Performance Bulletin

60049 Plastic Bypass Updates & Availability

41687 Wrench for Re-Designed Plastic Bypass

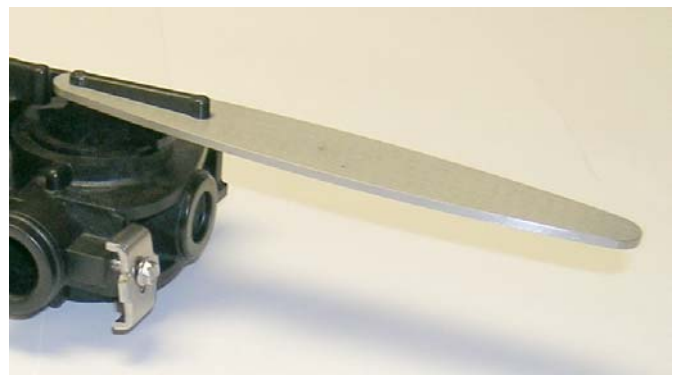
Beginning in July, a wrench is available (part number 41687) for the new plastic bypass (part number 60049).

3. Checking Backflow (Cross Connection Check)

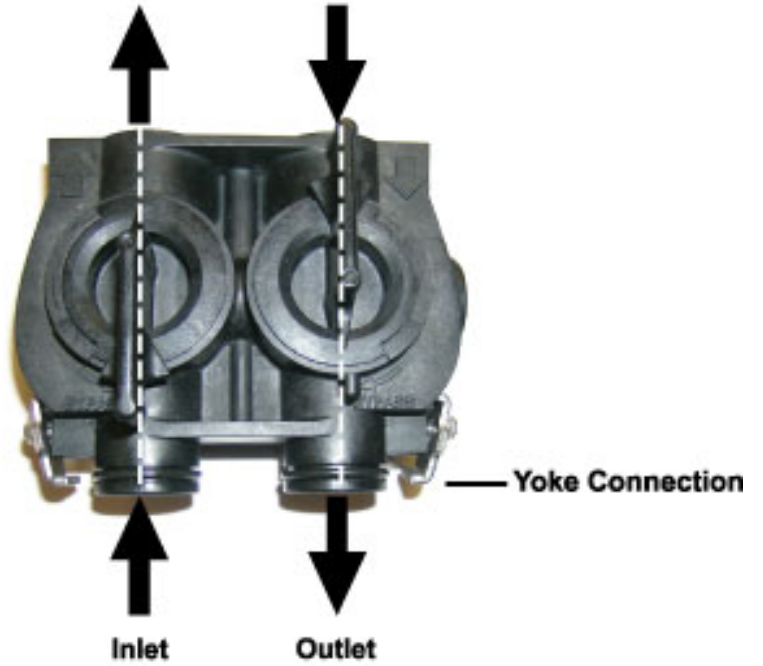
"Checking Backflow" Flow Path Change:

The third flow path in Performance Bulletin #435 has changed. Please see the following page for all flow paths.

Revised Flowpath
